Waterfront West

To the Waterfront West Ad Hoc Committee,

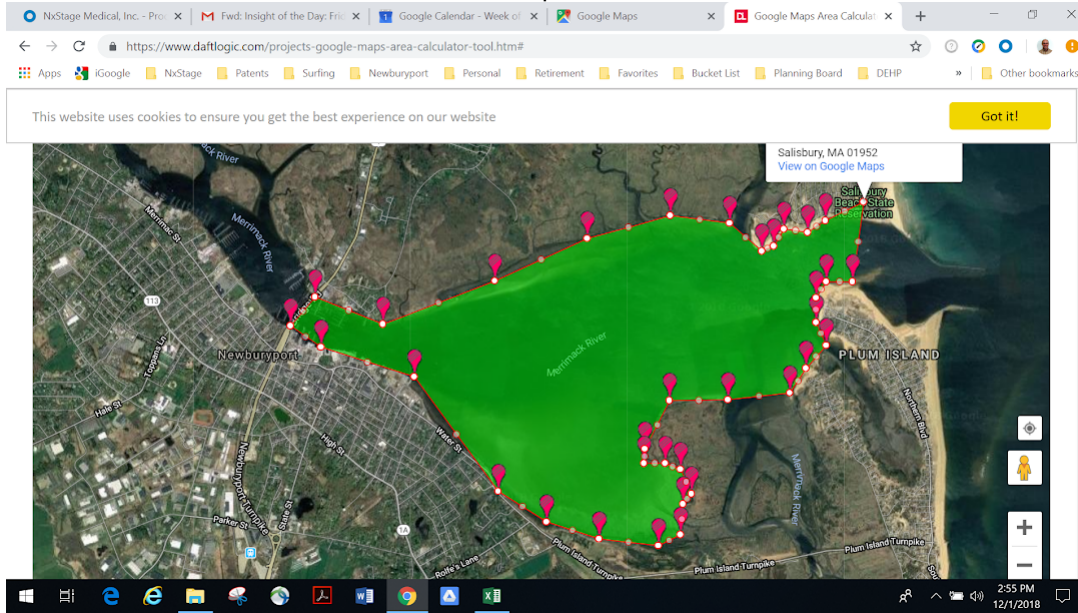
The area of the Merrimack and Jappa in the vicinity, see clip above using <https://www.daftlogic.com/projects-google-maps-area-calculator-tool.htm#>.

The google website calculates the area colored green (notice all the area near the Plum Island bridge would be part of the area as well) and gives 1563.99 acres.

The math is: $(2.5 \text{ acres} \times 7 \text{ ft}) / 1564 \text{ acres}$, which calculates out to 0.003 inches increase in water level (taking the full area makes it even less). For reference, the Human Hair is on average 0.004 inches in diameter. The issue raised regarding fill causing additional flooding is a non-issue.

Given the ratios of water covered area to the volume of fill, it is like tossing a rock in a swimming pool.
